SITE PLAN & ARCHITECTURAL
COMMISSION
AGENDA
MARCH 6, 2015

Subject: In-N-Out Burger Site Plan & Exception Request (AC-15-002 / E-15-003)
In-N-Out Burger, Applicant (Jim Lockington, Agent)

Consideration of plans for the construction of a 3,750 square foot In-N-Out restaurant and associated Exception request seeking relief to minimum front yard setback requirements in Medford Land Development Code Section 10.721. The subject site is located on the southeast side of Crater Lake Highway (Highway 62), approximately 500 feet northeast of Route 99 (Pacific Highway) on a 1.04 acre parcel, within the C-R/F (Regional Commercial/Freeway Overlay) zone district.

SITE PLAN

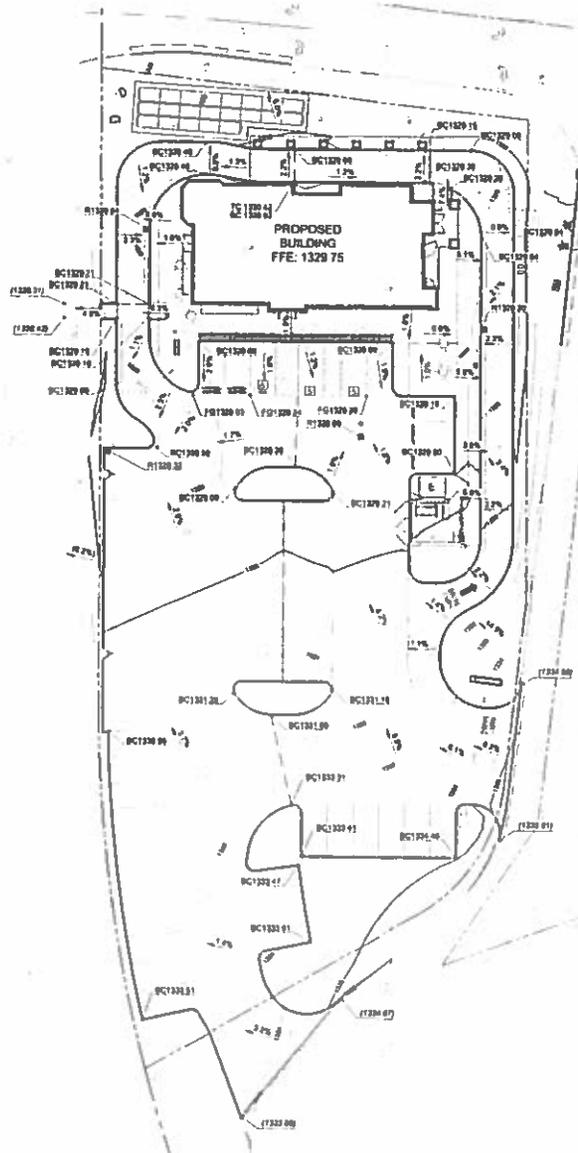
Proposed access to the site will substantially change from the existing fueling station use. There will be no ingress/egress provided to the driveway that provides access from Highway 62. The fueling station currently has two points of access from the interior driveway that encircles the Rogue Valley Mall. The applicant proposes to relocate the access point which is currently located near the intersection of the mall entry drive and the interior ring road. The site plan demonstrates that this drive entrance will be relocated approximately 185 feet southwest of the current location to align with a two-way access lane associated with the mall circulation. Moving this access point will help relieve congestion at the intersection, thus providing better circulation for both the Rogue Valley Mall and the subject development. Only one point of access will remain generally the same, which is the ingress/egress at the far southwest corner of the site.

All internal drive aisles allow for two-way vehicle maneuverability throughout the site. The site plan demonstrates that 90 degree parking is utilized throughout the parking field. Handicap parking and vanpooling spaces are located at the front of the building. The drive-through window is located on the rear of the building, facing the mall entry road. The site plan shows a long drive-through queuing lane, which can stack up to 15 vehicles behind the pickup window. The drive-through queuing lane begins at about the middle of the site along the south property

Per Section 10.743 of the MLDC, a minimum of 43 parking spaces are required for the proposed development and a maximum of 53 parking spaces is permitted based on the square footage of the restaurant. The applicant has proposed a total of 54 parking spaces, which is one space more than the maximum permitted by the MLDC. Therefore, staff has included a condition of approval requiring the site plan submitted for building permit to eliminate one parking space from the proposed development.

As noted above, the drive-through queuing lane provides stacking for up to 15 vehicles which exceeds Development Code requirements for a drive-through window. The site plan identifies one pedestrian access to the building from the sidewalk along Highway 62 to the patio area adjacent to the building and which extends over the drive-through lane on the north side of the building. Staff notes it is anticipated that the business will likely see a significant level of pedestrian traffic to and from the Rogue Valley Mall. While there is no code provision requiring a pedestrian pathway to cross the landscape area and drive through lane on the south side, similar to the pedestrian pathway adjoining the site to the sidewalk on Highway 62, Staff is recommending that the Commission include a discretionary condition of approval requiring a pedestrian crossing over the drive through lane on the south side, consistent with Section 10.775 of the MLDC, and that such path extend to the mall access drive curb south of the property.

Six bicycle parking spaces are required for this site, and six spaces have been proposed located on the front side at the northwest corner of the building. The style of bike rack is not identified on the site plan. Staff has included a discretionary condition of approval requiring that the six bicycle spaces be the inverted-U style of bicycle rack, consistent with the standard

The site plan demonstrates the enclosure to be constructed of block approximately 6 feet in height. A detail of the enclosure or note is not included on the site plan. Section 10.781 requires doors shall be made of solid wood or metal and that the enclosure be constructed for material which is compatible with other structures on the site. A condition of approval has been included requiring the building plan set to include detail of the enclosure which demonstrates compliance with section 10.781 of the MLDC.

Specifically the site plan demonstrates the drive-through lane being placed 5.25 feet away from the north property line, thus the paving area encroaches into the required 10 foot setback by 4.75 feet. In the mid-portion of the site, several parking stalls are located 1 foot away from the north property line, thus the parking stalls extend 9 feet into the required setback. In the southwest corner of the property the parking stalls are shown to be 3 feet from the north property line, thus the paving area extends 7 feet into the required setback.

The area of the parking lot in the south portion of the site can be revised through either reducing drive aside width, as 25 feet is provided and only 24 feet is required by the MLDC. Or, the several parking spaces along the south portion of the site can be converted into compact spaces. With either one of these revisions, or combination of both, the 8 foot buffer can be extended to 10 feet. Staff has added a condition of approval requiring the revised site plan submitted for the building permit reflect a 10 foot buffer between the parking lot or vehicle maneuvering area and the Highway 62 sidewalk.
